DESTINY INTERNAL MEDICINE

CONSTRUCTION DOCUMENTS

City of Aurora Building Division
Project: *DESTINY INTERNAL MED. (TMCA)*
Address: *1400 S POTOMAC ST UNIT 201*
Occupancy Group: *IBC B*
Construction Type: *IIB-SPK*
RSN: *2014665*
Permit: *26-2665817 -LT*

City of Aurora Building Division
Reviewed for Code Compliance
Approved as Noted: *Y.MUNOZ*
Date: *Nov 09, 2026*
2021 INTERNATIONAL CODES & 2026 NEC

A2 **LEVEL 2 - REFLECTED CEILING PLAN**
1/4" = 1'-0"

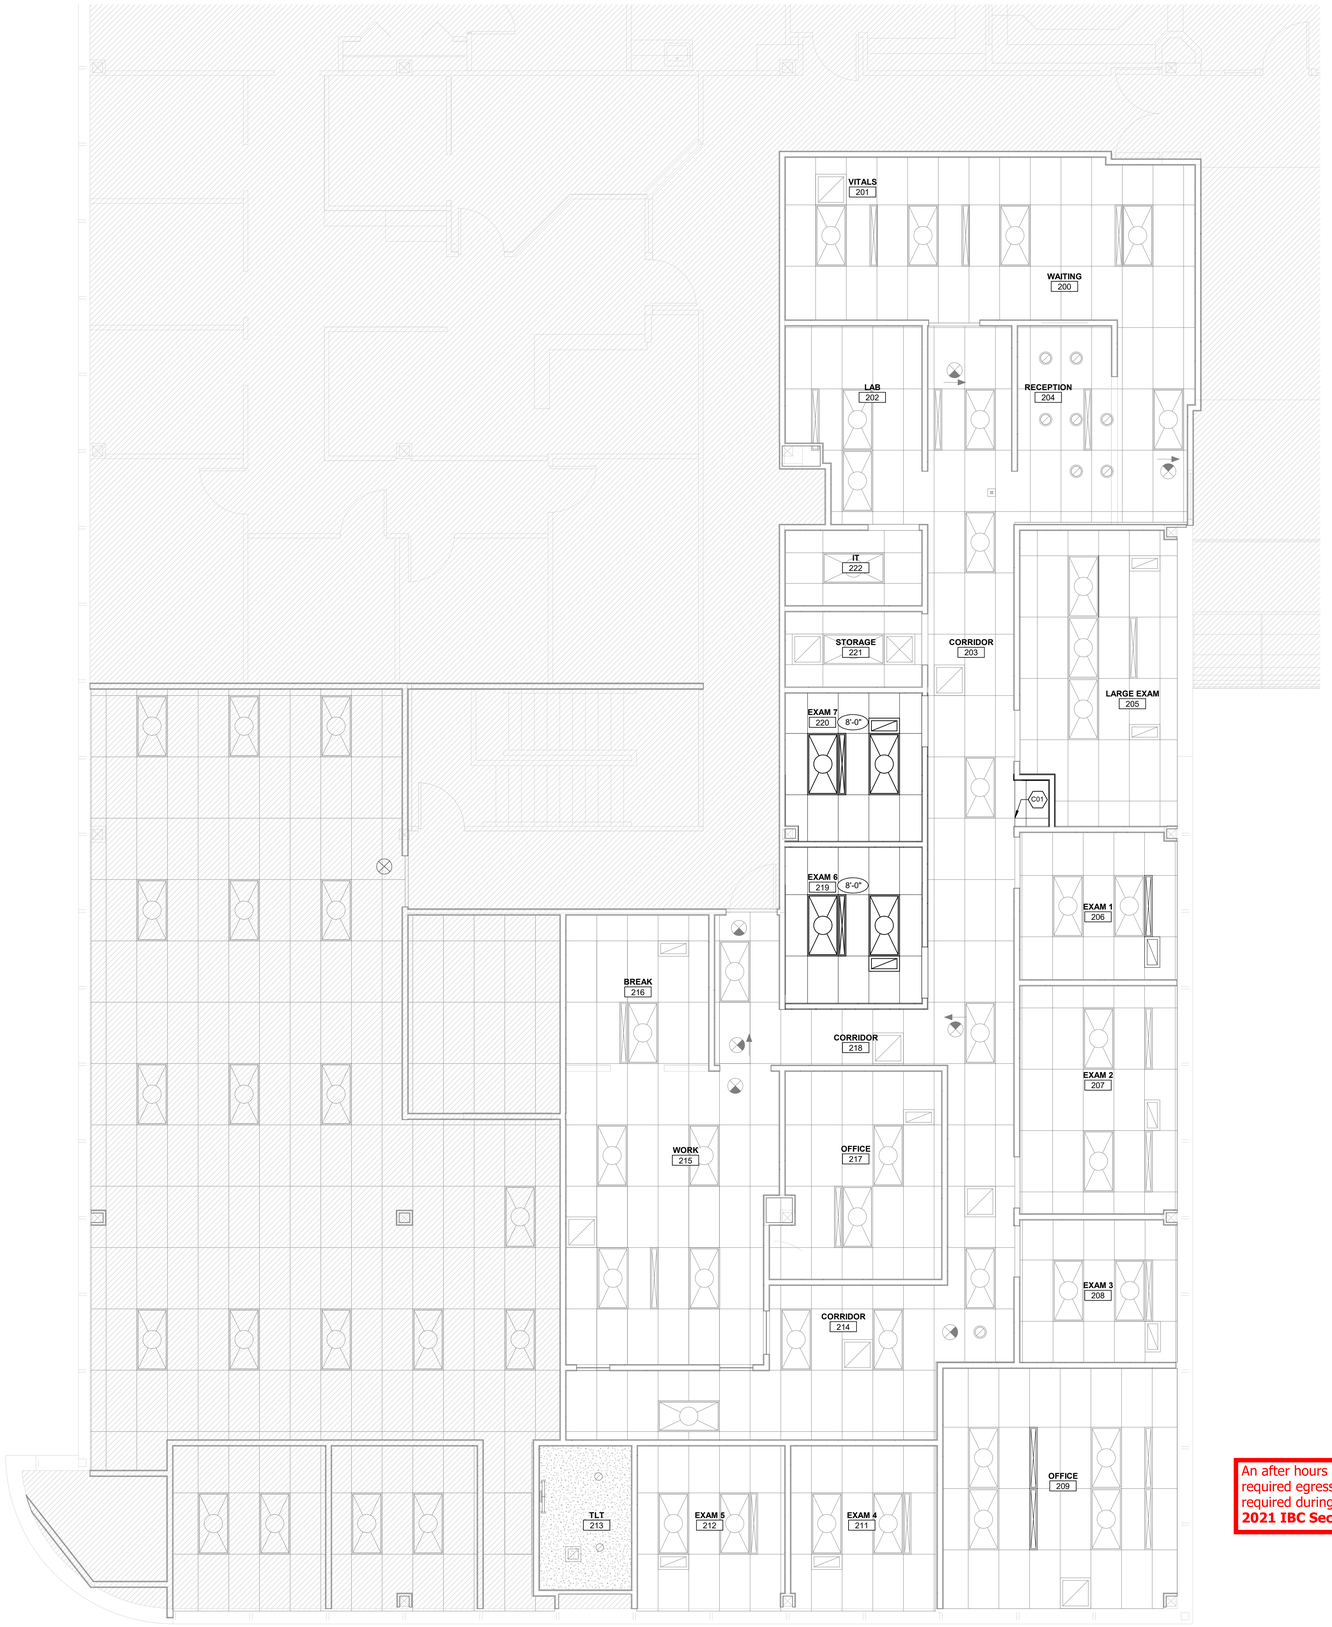
An after hours inspection to verify required egress illumination may be required during field inspection
2021 IBC Sec 1008

LEVEL 2 NEW WORK MECHANICAL PLAN 1

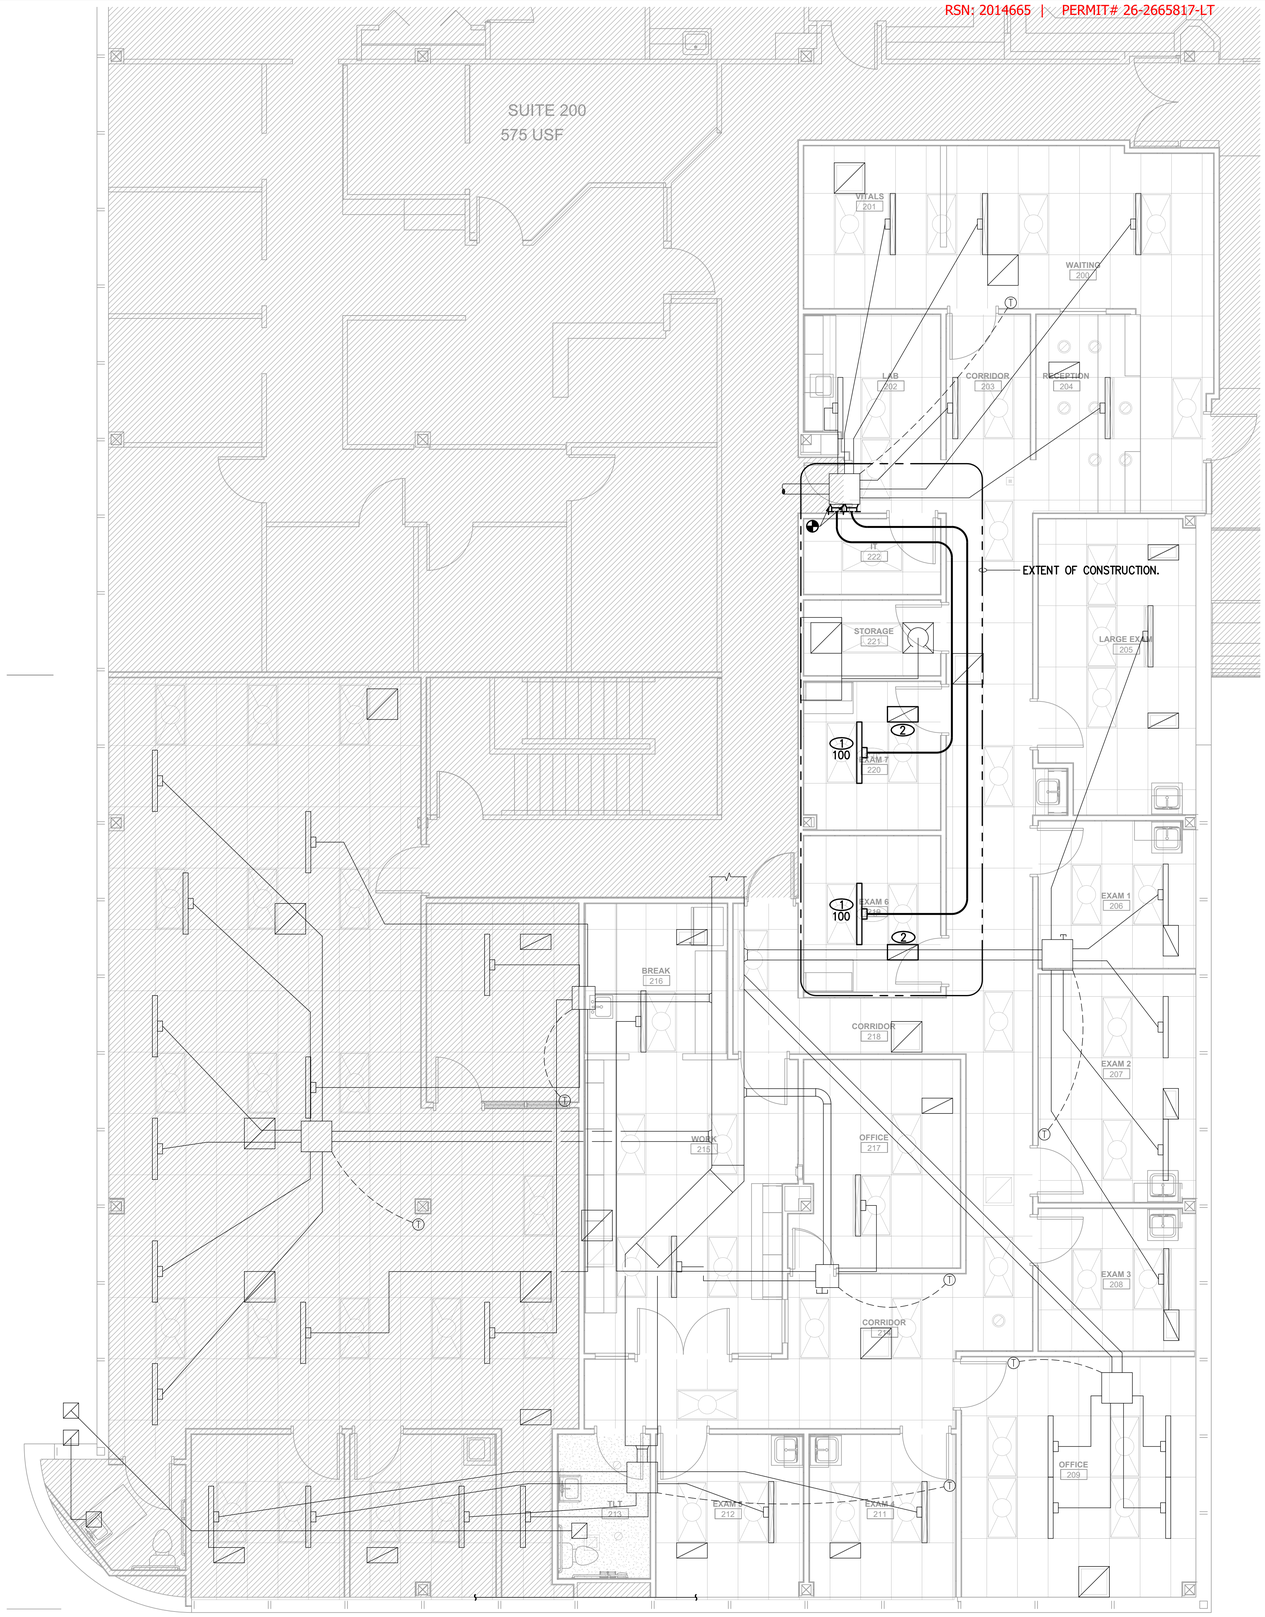
Provide proof of a flame spread index not more than 25 and a smoke-developed index not more than 50 for any material used in a plenum.
2021 IMC 602.2.1
